RE: Petition No. 1226
Towantic Switching Station and Line Modification Project

To incorporate the FAA's conditions of lighting into the Project design documents, Eversource proposes to add notations on Mapsheets 21-23, which depict the structures affected by the FAA determinations. The modified Mapsheets 21-23 are included in Attachment E.

BUNKER HILL - OXFORD
115KV TRANSMISSION
FAA LIGHT & SOLAR PANEL ARRANGEMENT
OXFORD/WATERBURY/MIDDLEBURY, CT

REVISED PETITION MAPSHEET 20-22

Data Sources:
CAI
GZA
Eversource
CT DEEP
AECOM, Davison
FEMA
Base Map acquired from
ESRI Online.

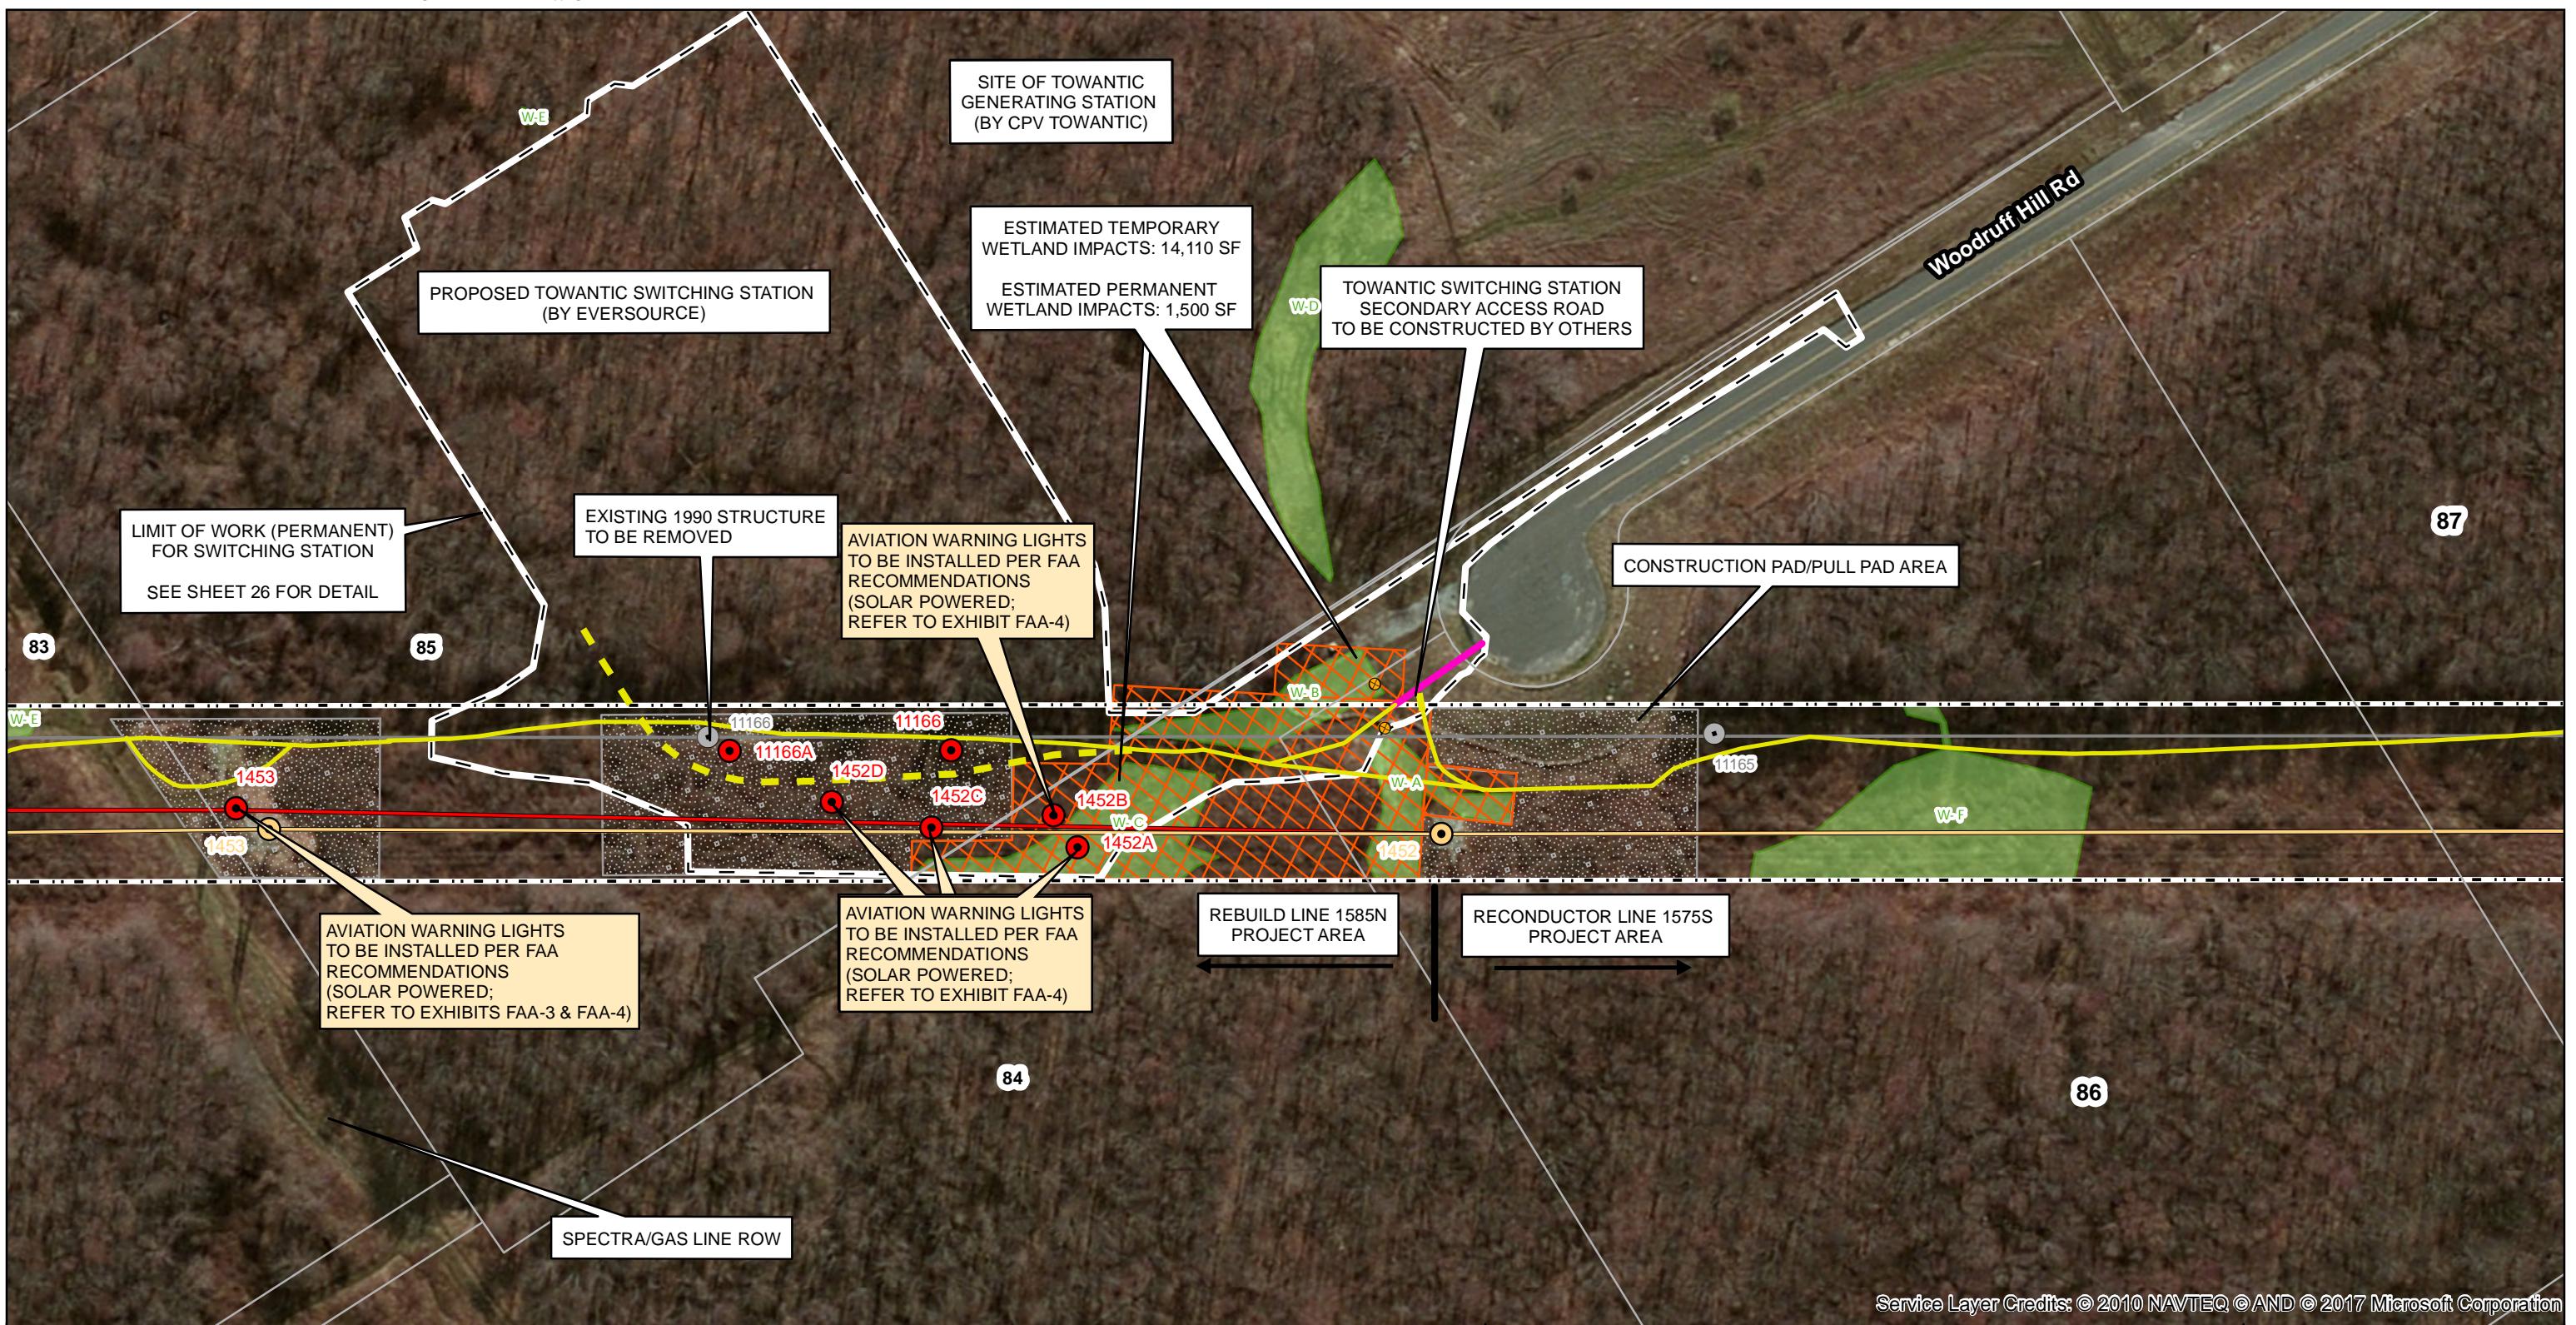
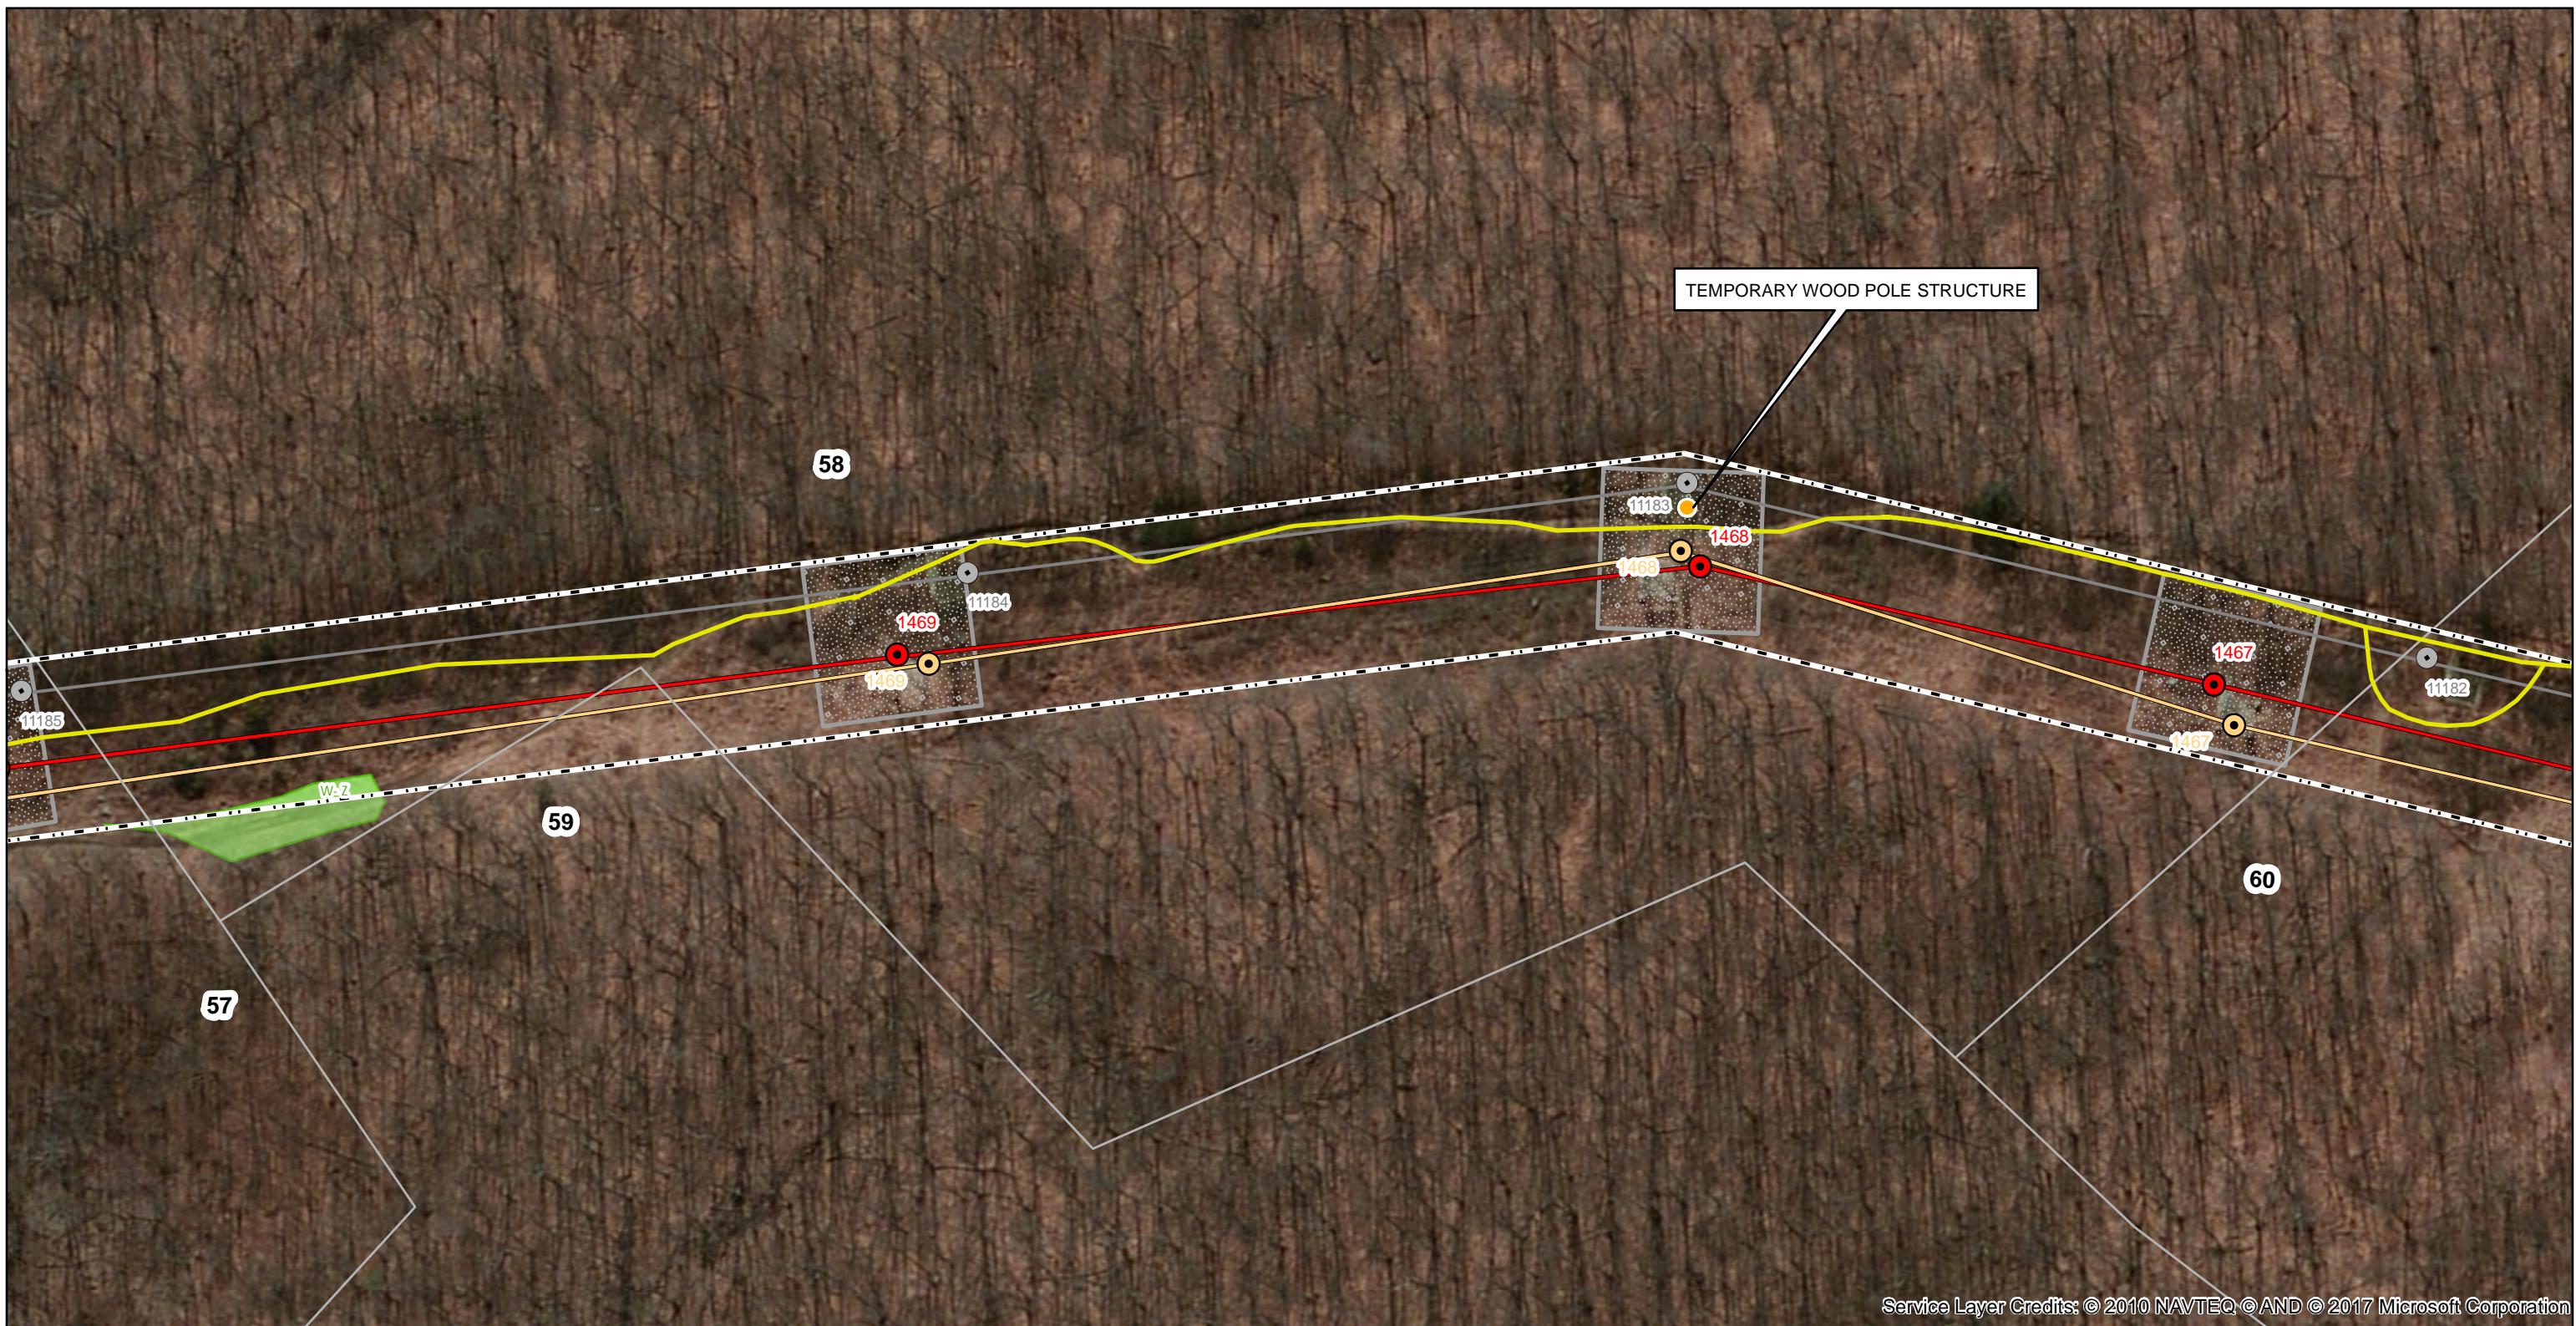
INCORPORATING LIGHTING MODIFICATIONS

REVISED PETITION MAPSHEETS 15 AND 19

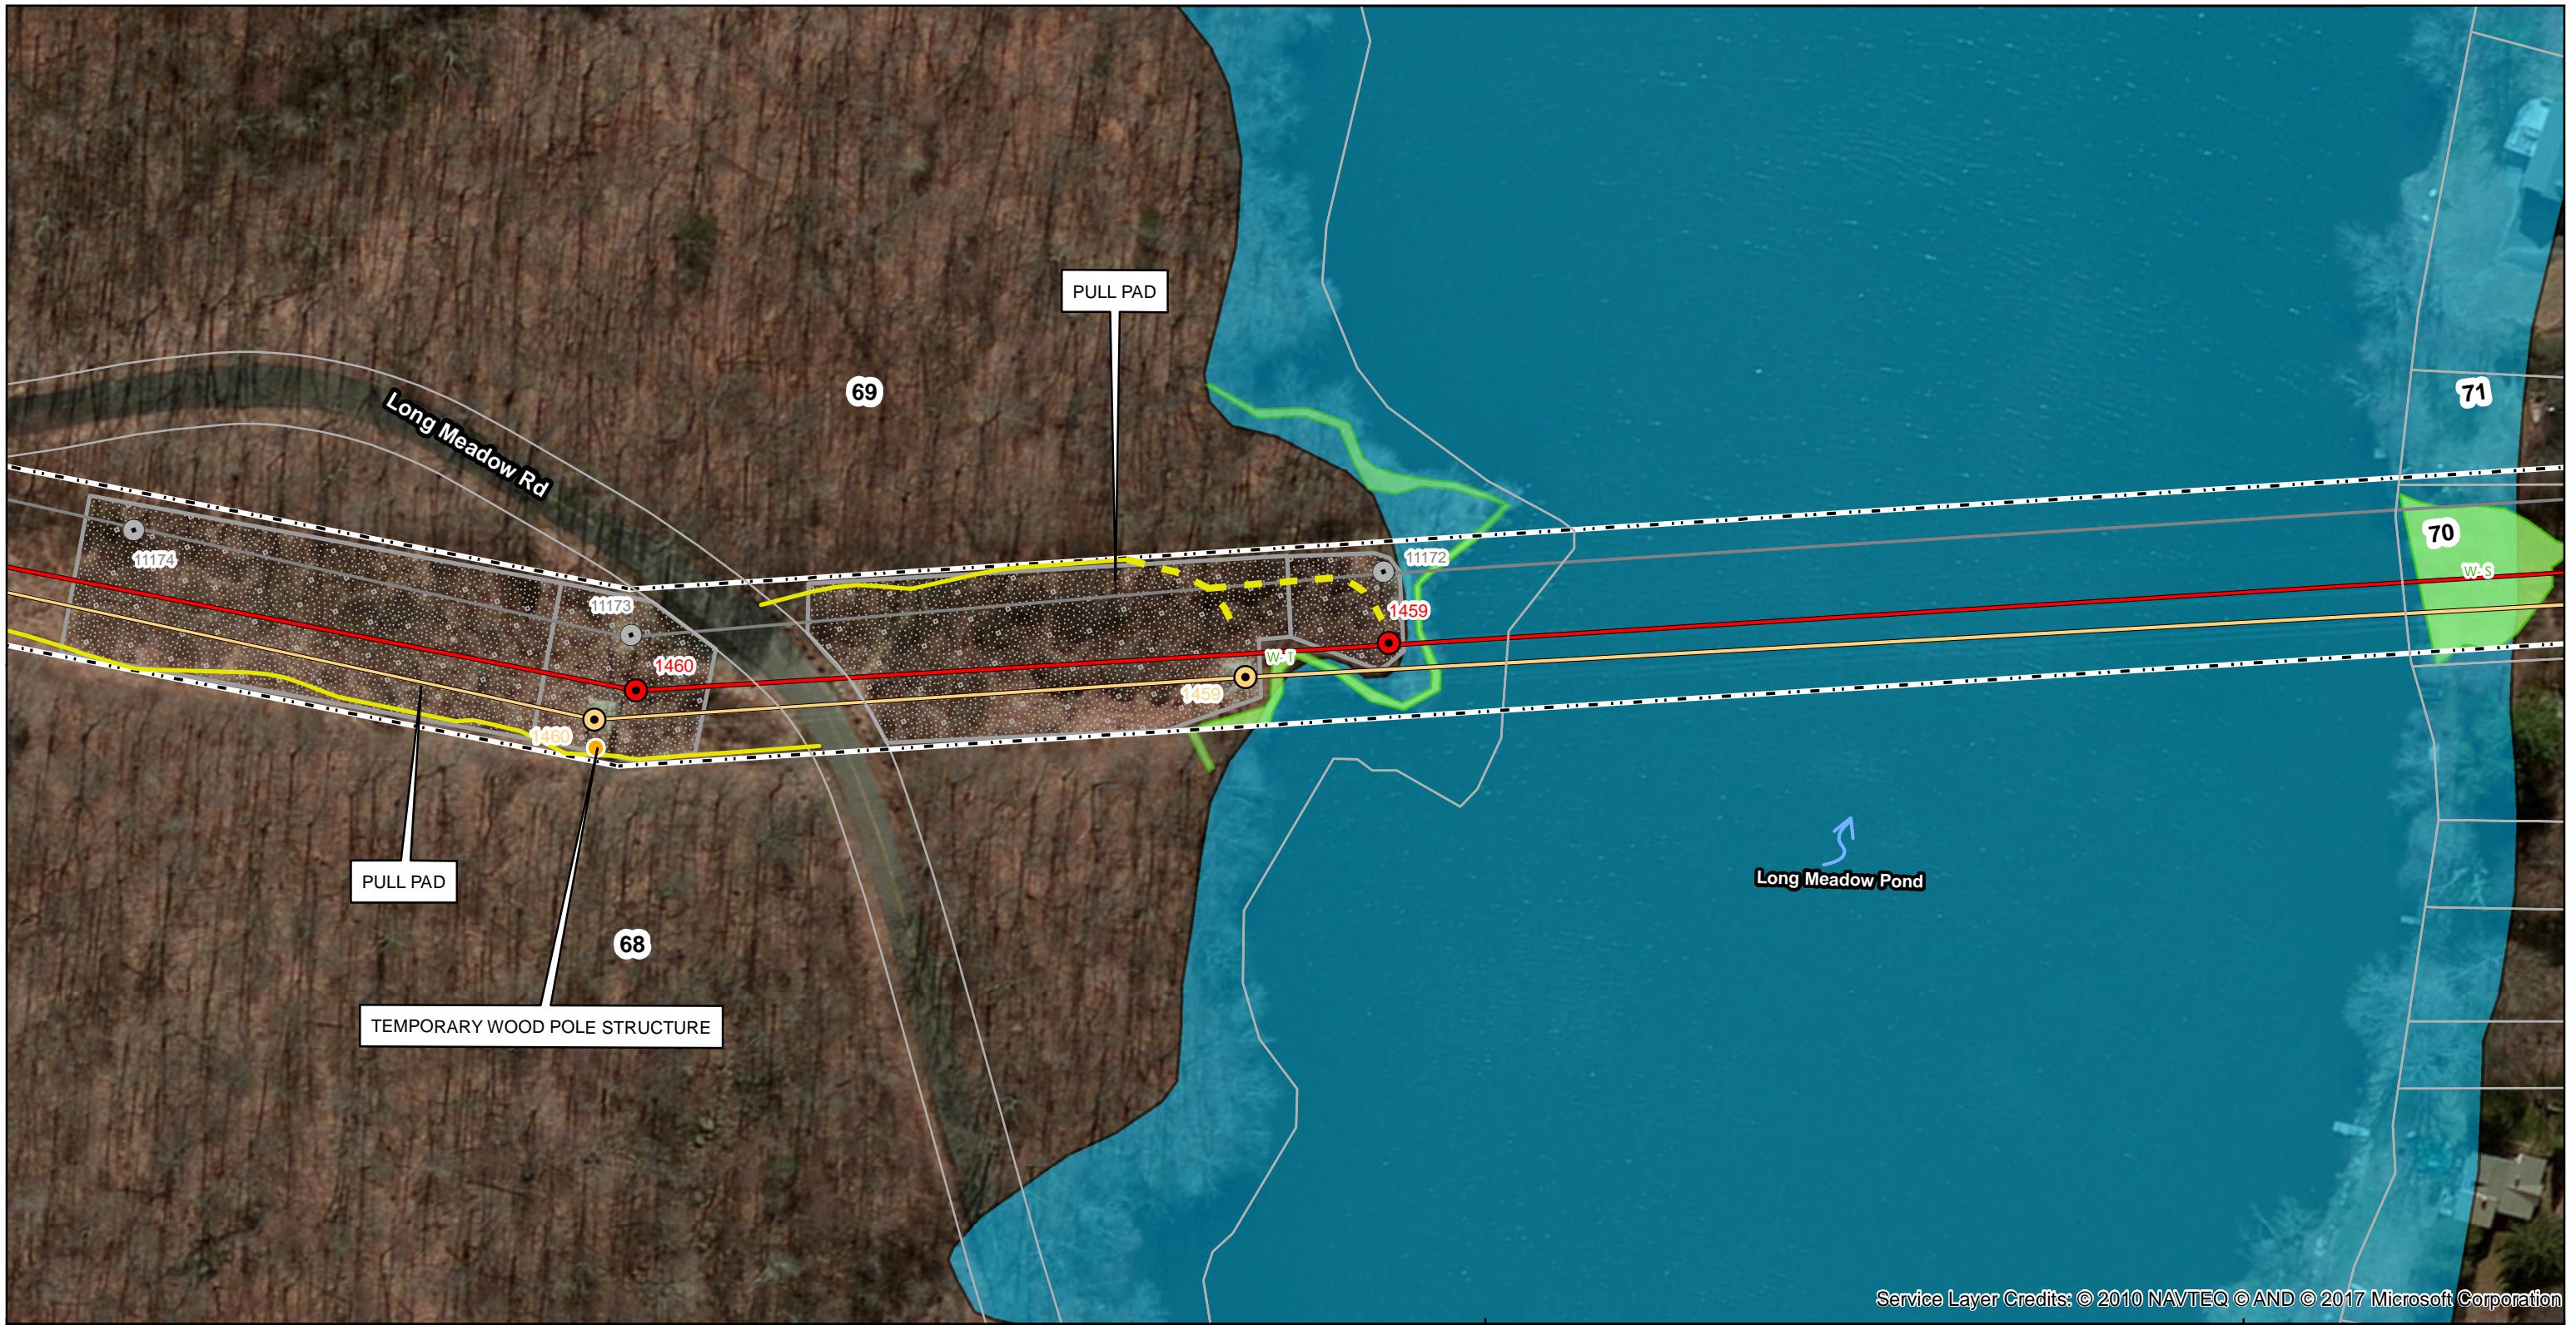
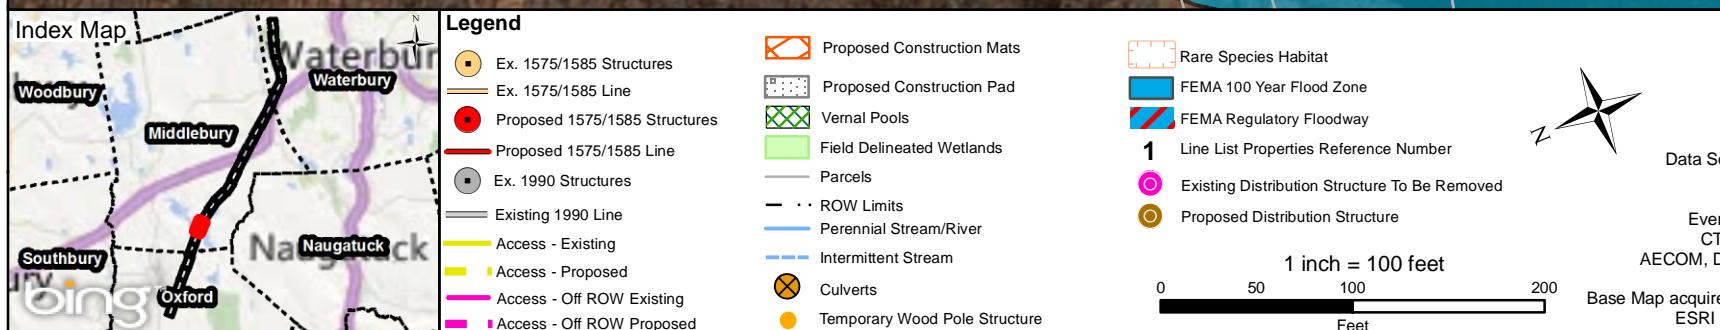
In addition to the above response to the Council's condition of approval, Eversource is requesting approval for the installation of two temporary wood pole structures at Structure 1460 and Structure 1468. The temporary wood structures will be approximately 75' in height and are depicted on Mapsheets 15 and 19 included in Attachment F. The purpose of these temporary poles is to relocate the existing conductor while new structures 1460 and 1468 are being installed. Currently, the 1575 line and the 1319 Line are the two sources of supply to Oxford Substation, which serves approximately 8,000 customers. The temporary poles have been determined to be required in order for Eversource to provide timely restoration to the 1575 line while construction is in process and during the scheduled outage, if there were to be a failure of the 1319 line. The temporary structures are proposed to be installed in March 2017 and will be removed in June 2017.

TEMPORARY WOOD POLE LOCATIONS
